CITY OF OREGON CITY HISTORIC REVIEW BOARD AGENDA

Staff Report

GLUA-22-00004 and HR 22-0001: Historic Review for modification of HRB decision HR-20-04.

REQUEST: Historic Review for a revision to the location of the detached garage and tree mitigation plan for a an approved (GLUA-20-00007: HR 20-04) single family home and detached garage in the Canemah National Register District.

Approved site plan

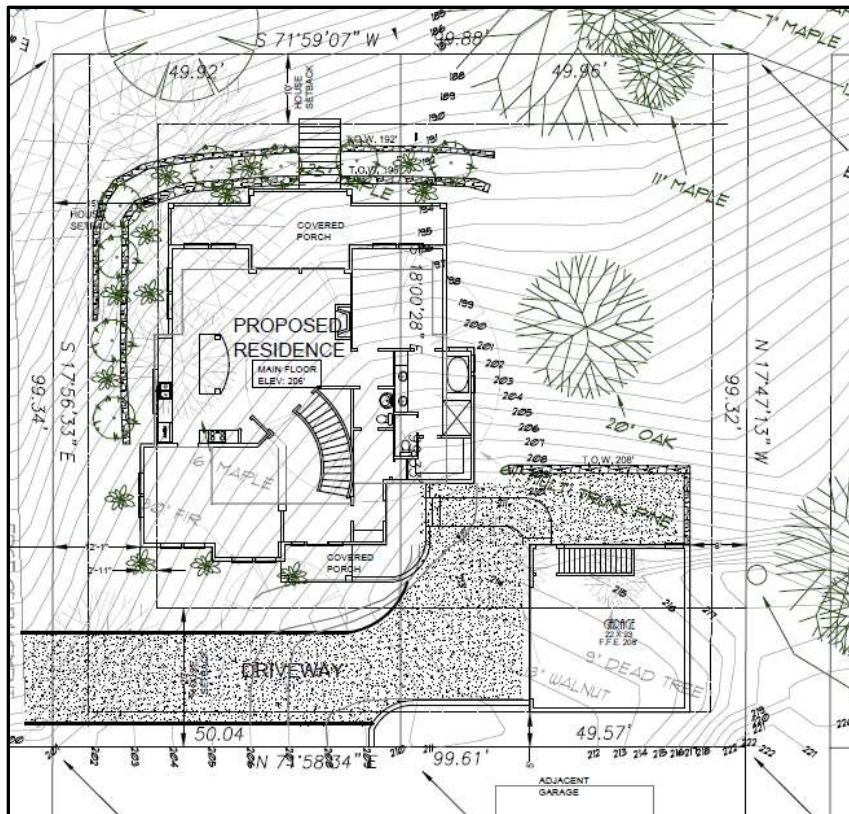
It is not clear what the prognosis would be for these trees if the construction footprint were pulled back to the original plans. The oak, if preserved, would greatly help with screening of the structures from 4th Avenue.

The design guidelines for New Construction contain a provision regarding foundations – under “Not allowed:” – “Tall or expansive areas of exposed foundations.” The 6 feet of exposed foundation is significant, especially when sited next to the home, which itself has a lower level that is greatly exposed. On the other hand, the HRB may find that the foundation exposure is acceptable because it is set back 48 feet from the property line and vegetative mitigation may be possible to reduce the visual impacts.

Proposed revision

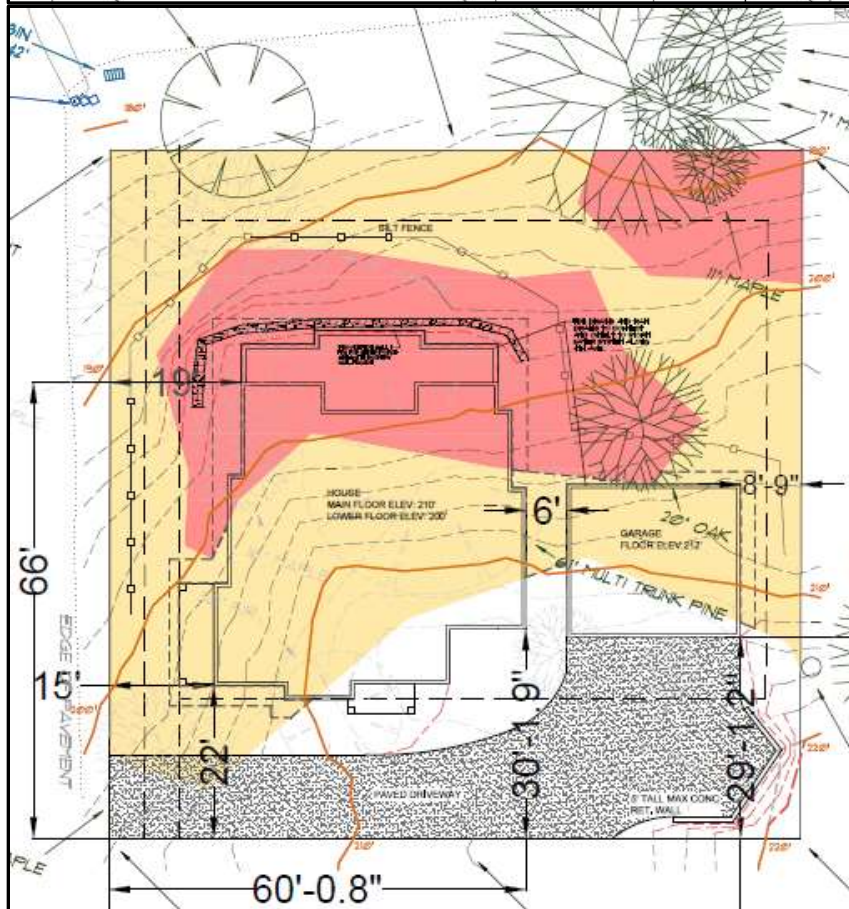
The applicant proposes this change to limit disturbance and excavation within the steep slope area of the site. However, it is not clear that overall disturbance will be adequately reduced with this plan, since the driveway pavement is significant. It appears that there may be other placement options or layouts that would better meet historic design guidelines as well as accomplish a reduction in the overall disturbance of the site.

The previously approved plan that placed the garage in the back corner of the lot included less driveway pavement, more opportunity for tree preservation, and greater garage setback from the street, along with less foundation exposure. The new plan has a greater impact on the vegetation on the property, and the exposed foundation of the garage is not as consistent with the design guidelines. Therefore, staff recommends denial of the proposal, or, approval with conditions to mitigate the impacts. Whether mitigation is possible is not clear at this stage, so staff recommends that the HRB provide some direction on additional information or changes that may be helpful for review at a continued hearing.

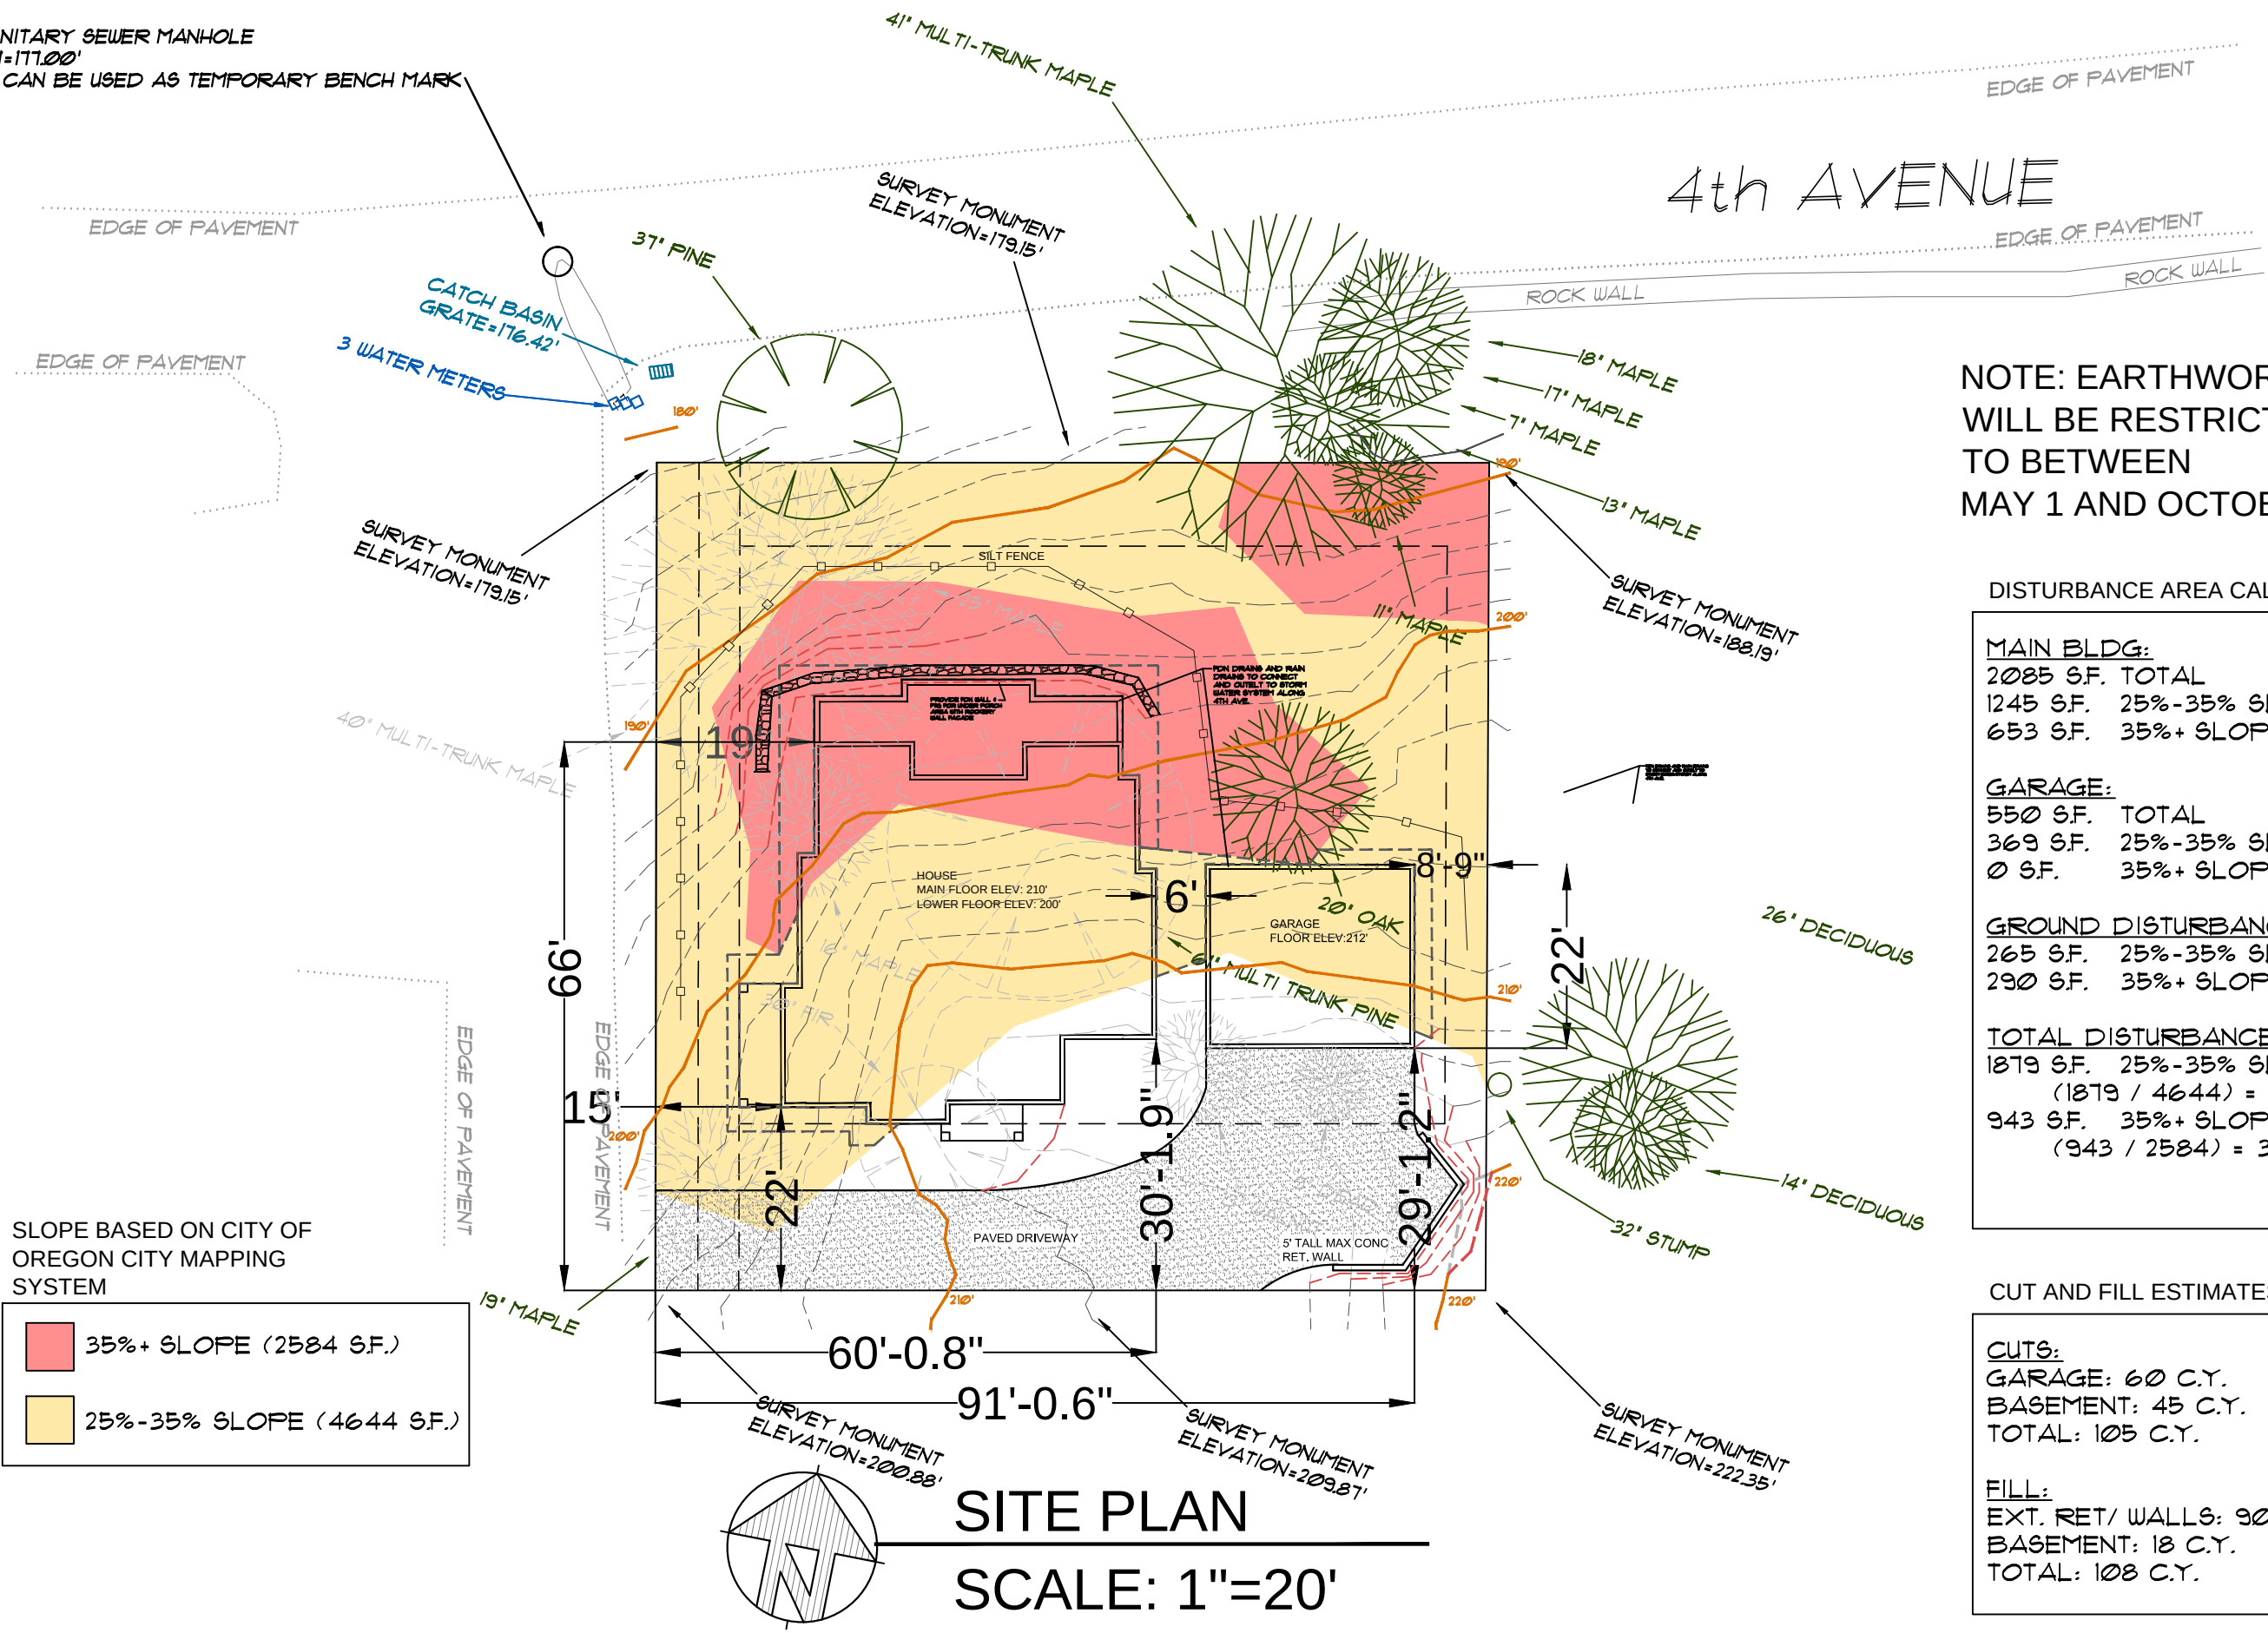
With our Historic board application approval in May 2020, 7 trees were identified to be outside of the envelop of construction and, therefore, were called out for preservation. However, upon closer examination of the health of trees by an arborist, revisions to tree preservation plan are requested. Three of the trees were identified as doubtful for surviving construction and, therefore, are proposed to be removed.

- 1) 37' Pine located, about 15 inches in diameter, on the corner of 4th and Hedges (NW corner).
- 2) Alongside the 4th (South) 41' Multi-trunk Maple.
- 3) 20' Oak towards the middle of the lot, near proposed garage.
